Re: Tecumseh Road E.A.,
Via Rail Crossing at County Road 19 (Manning)

Re: Manning Rd.-Tecumseh Rd./CNR Railway Crossing Reconstruction

RE: County Road 2 (Tecumseh Road) EA

Re: Barde Homes Ltd. (Dennis and Barbara Kenny)
Kenney Plaza Exit/Entrance at Manning Road, Tecumseh

VIA-RAIL-1.jpg

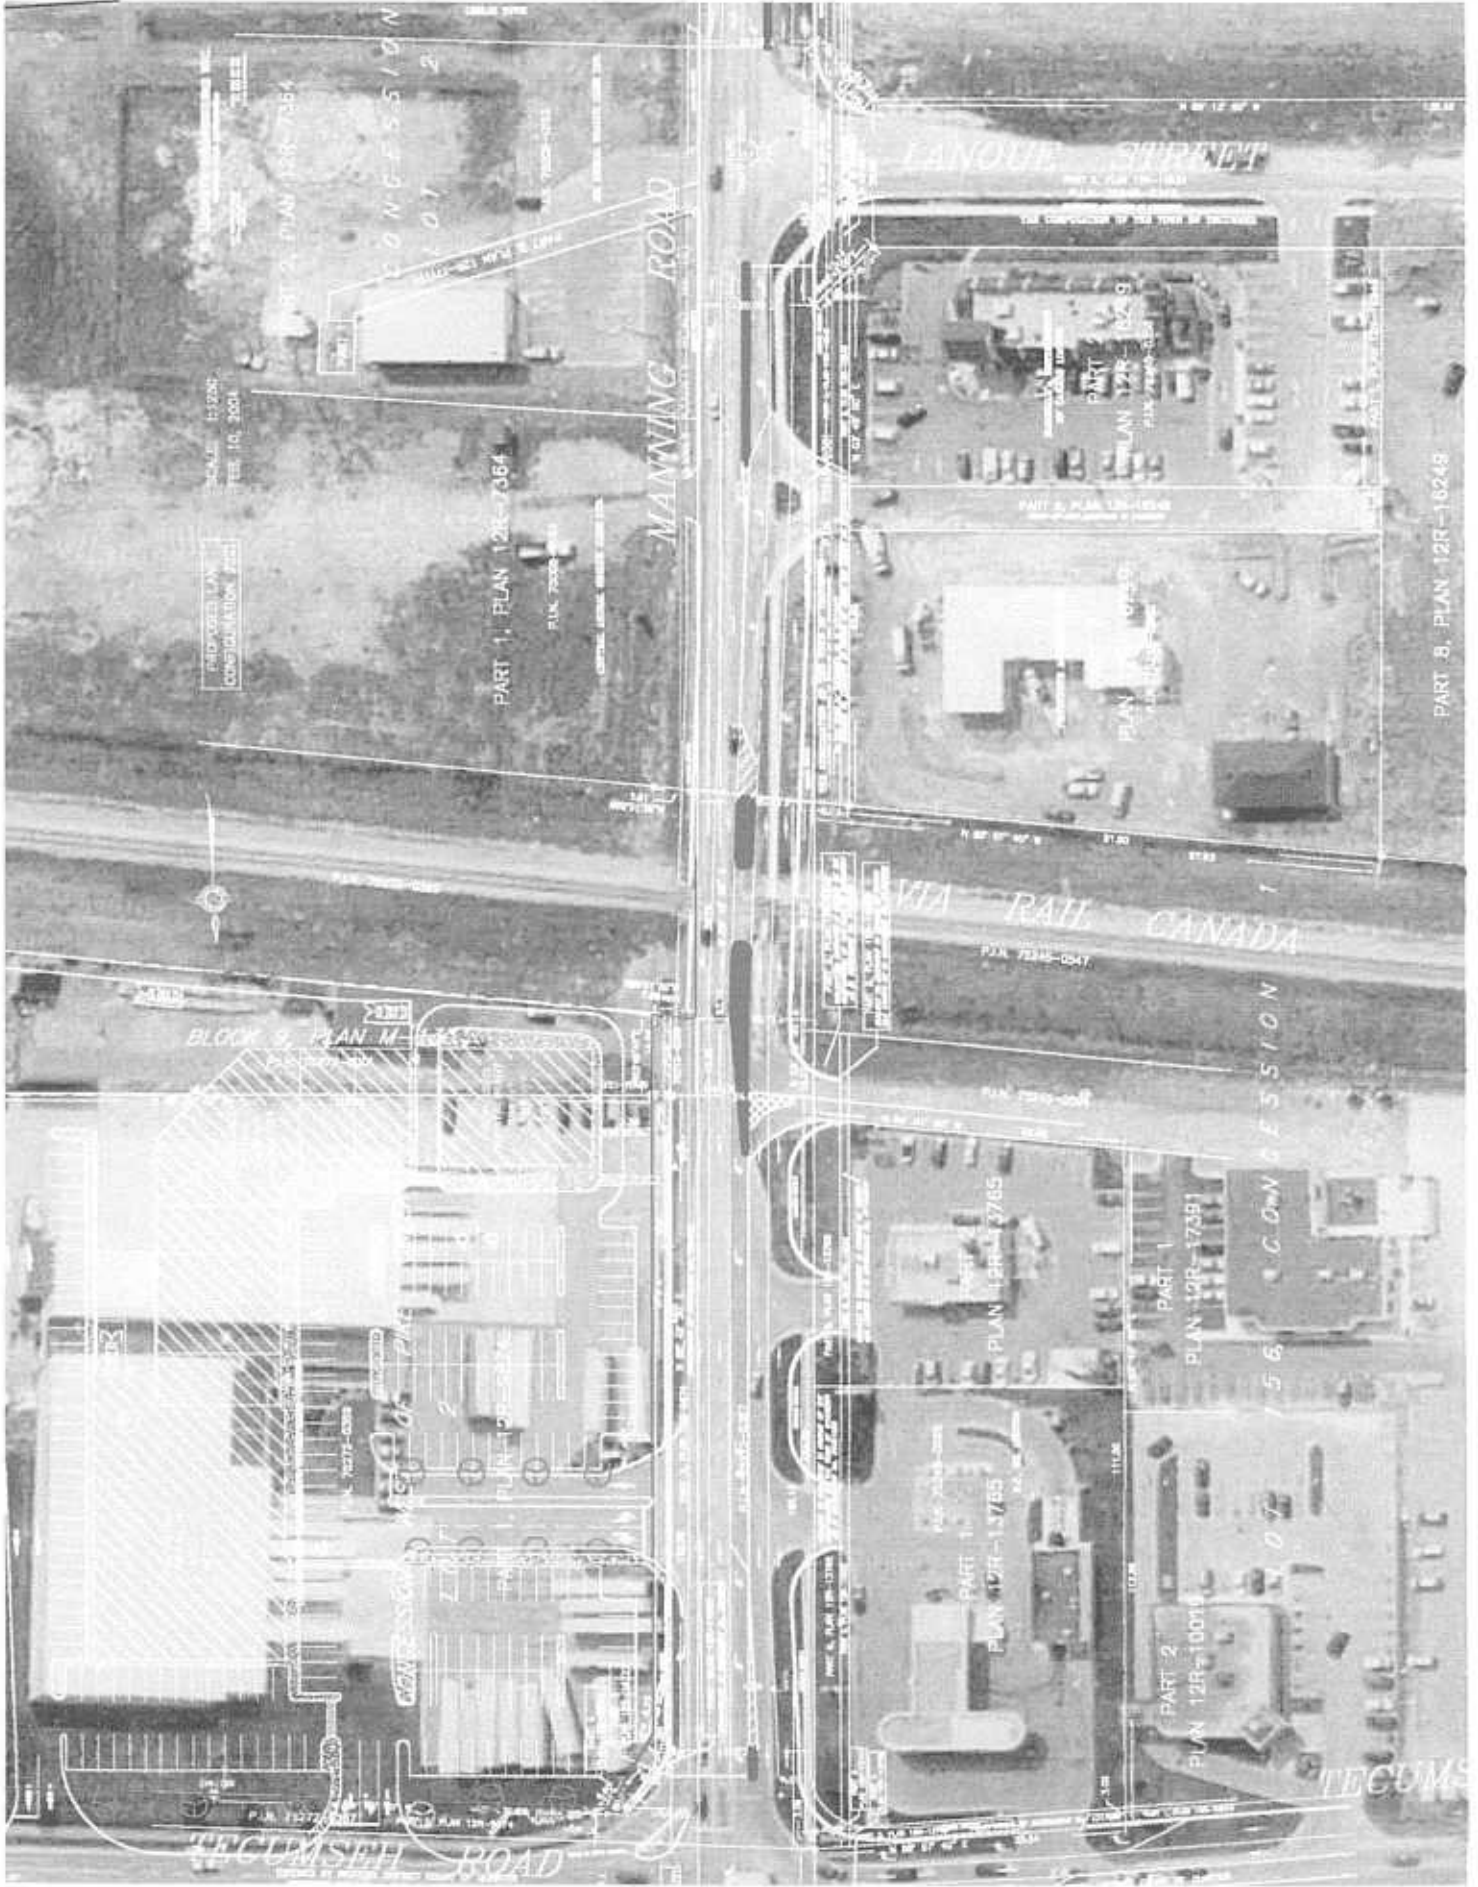
Our initial review of the proposed lane configuration on County Road 19 (Manning Road) has identified a critical issue that must be addressed.

The proposed lane layout indicates the ability to allow northbound left turn movements into an improved driveway on the west side of County Road 19 immediately north of the rail crossing.

These movements are problematic in that the short storage length provided could potentially allow vehicles attempting to undertake the left turn to stack into the center northbound travel lane. Of more concern is the potential to block vehicles onto the railroad tracks. Knowing the speed of trains through this corridor, it would present an extremely dangerous situation that the County cannot support, and we are confident that VIA would also oppose such a configuration.

We therefore suggest that the northbound left turn movement be prohibited through the use of a raised center median of sufficient length to prevent "shortcutting" around the median as currently experienced south of the rail crossing into the plaza. This driveway then would operate as a "right in/right out" access onto County Road 19, thereby creating a much safer environment.

A similar situation will exist south of the rail crossing related to southbound left turns. As the lands in this vicinity are relatively undeveloped the designs presented should address the potential future turn movements to eliminate potential hazards.

KENNEY ENTRANCE
OPTION #2

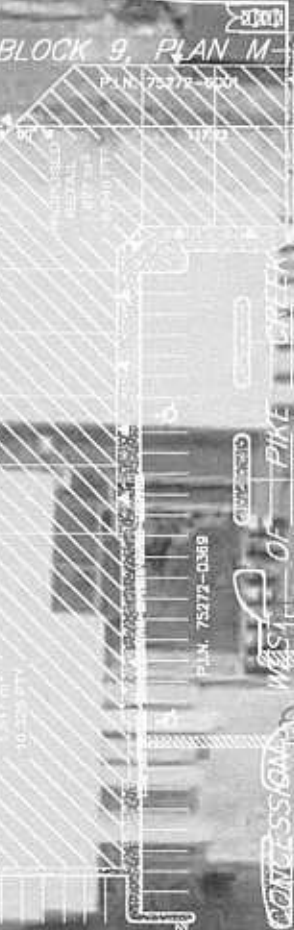
Thanks Rocco - This looks like a much better option - depending on the outcome of the site meeting, the worst case scenerio would be to loose the "left out" option. Ian Fogarty looks after railway signals for us and when I see him tomorrow morning, I'll go over this plan with him. What does your calendar look like for the 9th and 11th of June?

It appears sidewalks are shown on both sides of the crossing. If I'm correct, they must be located behind the signal masts, not in front of them. The centre-line of the signal mast will be located 4ft. 6in. back from the face of curb. - the crossing gate counter-weights extend approx 3ft. from the pivot point on the mast so that would be the closest point where the sidewalks could start. The centre-line of the sidewalks can be no more than 12 ft. from the centre-line of the signal mast or the sidewalks will require their own signal system. Hope this information is of some assistance.

We trust this plan addresses your concern for a continued right-in, right-out and a left-out only. This is the proposed construction on Manning to satisfy your concerns. We are also forwarding this plan to V.I.A. for their comments.
